## ERRATA SHEET FOR STANDARD SPECIFICATION BOOK FOR STATE ROAD AND BRIDGE CONSTRUCTION, EDITION 2007

The Kansas Department of Transportation **STANDARD SPECIFICATIONS FOR STATE ROAD AND BRIDGE CONSTRUCTION (2007 EDITION)** includes:

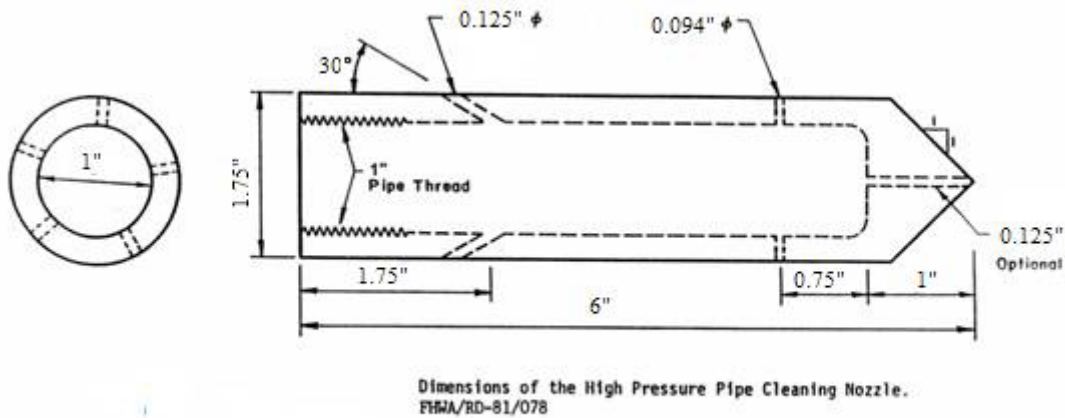
Page 800-100, replace FIGURE 845-1 with the following:
